TECHNICAL BULLETIN

Range Rover
Discovery Series II
Defender

Bulletin N°: 0029
CDS. ref: L8623bu
Issue: 1
Date: 15.11.2000

ENGINE WILL NOT START / STARTS INTERMITTENTLY

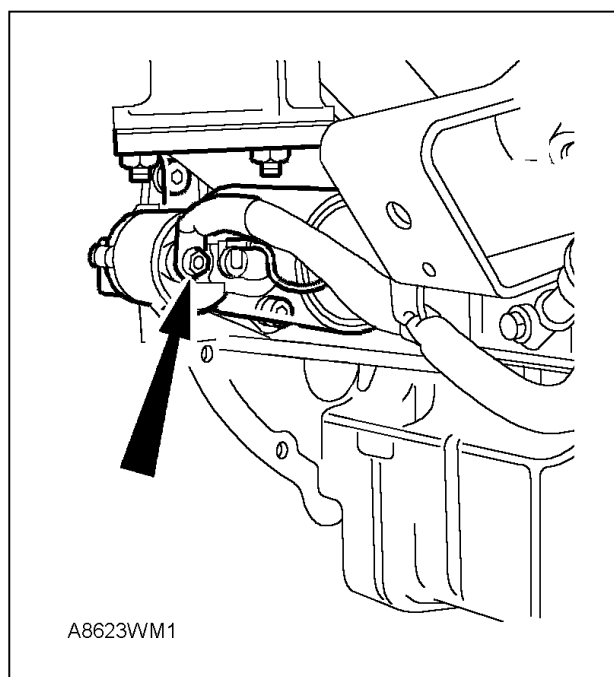
Poor electrical connection between the main battery lead and the starter motor solenoid.

At the final VINs above, the torque setting for the battery lead connection to the starter motor was increased from 10 Nm to 18 Nm.

1. Disconnect earth lead from battery.
2. Raise vehicle, (Discovery and Defender only).
3. Locate battery lead to starter motor solenoid connection, (arrowed in illustration).
4. Tighten solenoid nut to the new torque of 18 Nm.
5. Lower vehicle, (if necessary) and reconnect battery earth lead.
